## **Madison Metro Transit System**

SUBJECT: **702 North Midvale Boulevard – SIP Amendment #1 – Hilldale Restaurant**

Metro Transit has reviewed the subject development and has the following comments.

Site Layout Plan  
 Hilldale PUD-GDP-SIP Amendment #1  
 Restaurant / Water Feature

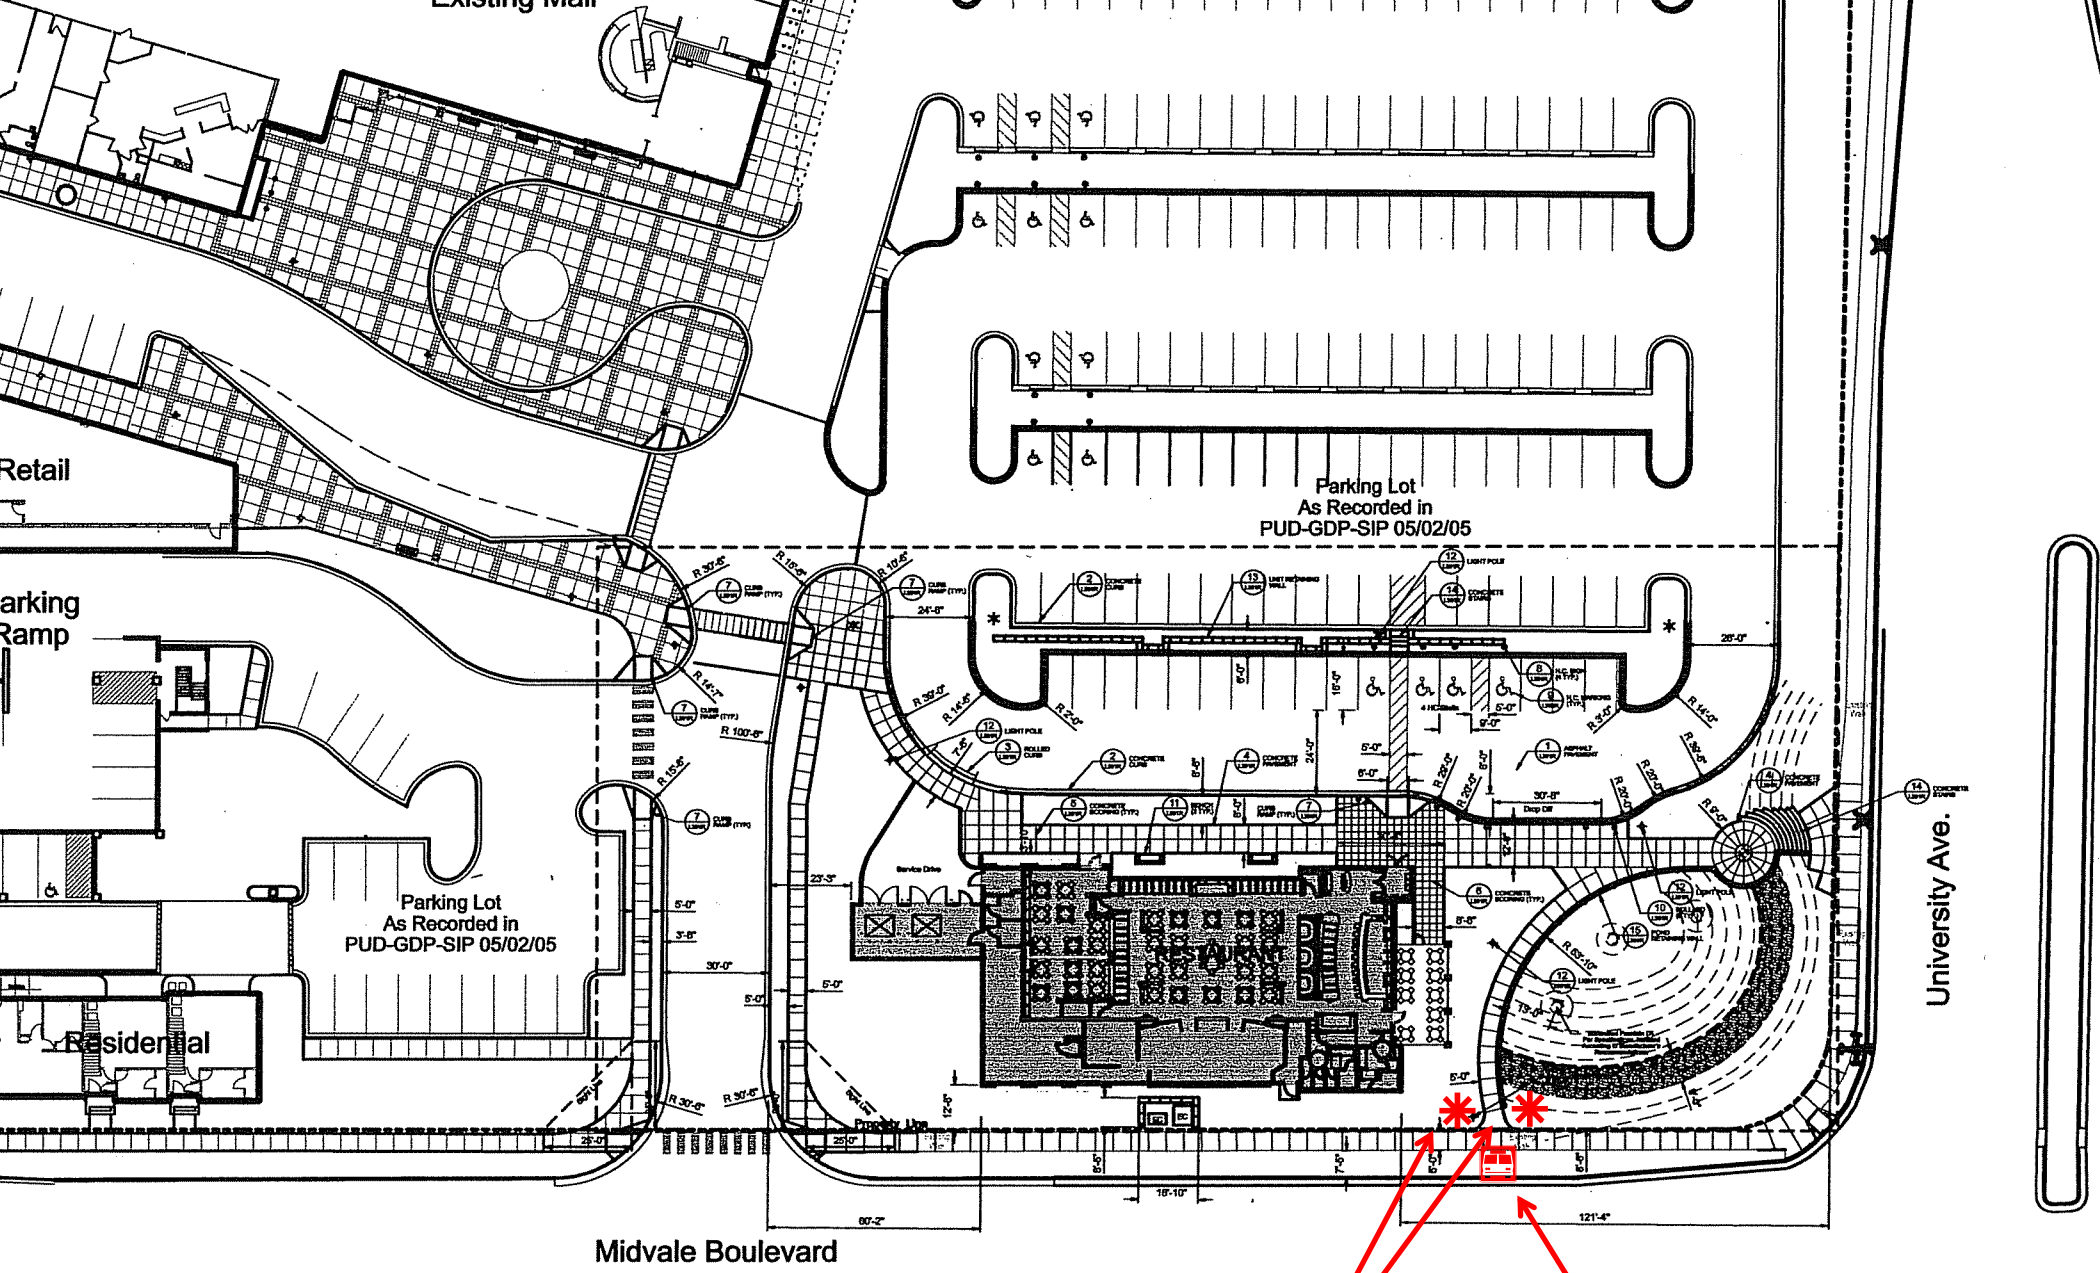
1. The applicant shall install a concrete passenger boarding pad on the west side of Midvale Boulevard, approximately 100 feet south of University Avenue, generally opposite the accessible pedestrian walkway. The concrete pad shall occupy the full distance of the terrace, measure 6 feet in width parallel to the street, and lie flush between the sidewalk and the top of curb.
2. The developer shall install and maintain a bench or other seating amenity and a trash receptacle on the property side of the sidewalk, to either side of the accessible pedestrian walkway apron.
3. The developer shall include the location of this concrete passenger boarding pad and the passenger amenities on the final documents filed with their permit application so that Metro Transit may review and approve the design.

Seating and trash site options

Concrete passenger boarding pad site
